Advanced Television Systems Committee

#### (Proposed) Revision of A/53C Annex D incorporating the EVSB Transmission Mode

## Harmonic Inc. Comments on ATSC PS/T3-596r3, A/53C Amendment 3

Figure C2 from CS-608 and CS-609

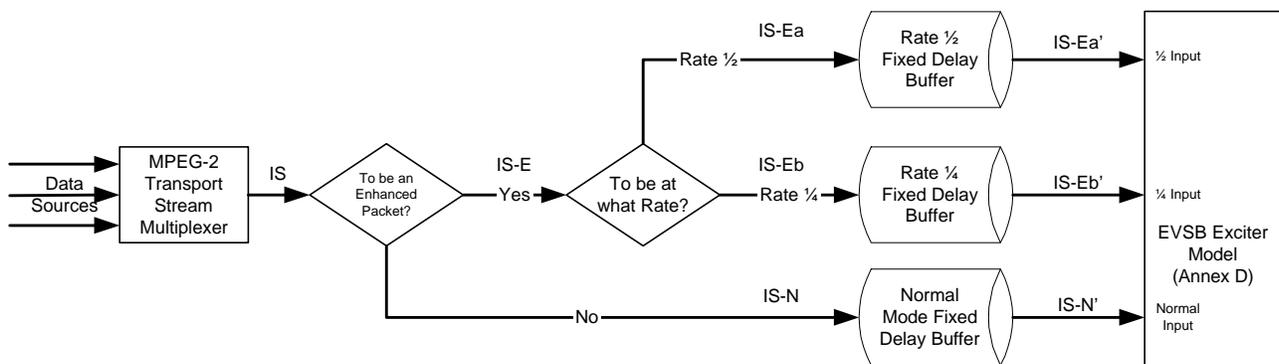
A change of map, such as may be forced to remain compliant with Section 5.6.1, may occur twice or more often a day. Such a map change requires tight coordinated action between the encoder, mux, and the yet to be built E-VSB front-end “demultiplexer.” This demultiplexer is based on Figure C2 from CS-608/CS-609 and is illustrated below:

Note that there are 3 “fixed delay buffers” at the input to the exciter. At the moment of map change (which always must occur at the start of an E-VSB “segment”, (1) the encoder making 1/2 rate audio and video must change (on a TS packet boundary) from 1,951,961.531 bps to 4,337,692 bps, while simultaneously the 1/4 encoder must change from 108,442.307 bps to 487,990 bps, and the main channel encoder must change from 14,420,181.93 bps to 7,210,090.966 bps.

Now note that the sum of the 3 streams NEVER is 19,392,658.46 bps. That rate must be produced ONLY when E-VSB is taken to zero. The actual multiplexer output TS rate will also need to vary at the change of a map, once again on a TS packet boundary...

What is missing from this Proposed Standard is any method of signaling between the E-VSB “Main and Enhanced Mux Packet Processor,” perhaps the E-VSB Exciter, and the Digital Compression System upstream. Such signaling is necessary to permit the operator to make the type of map change illustrated above.
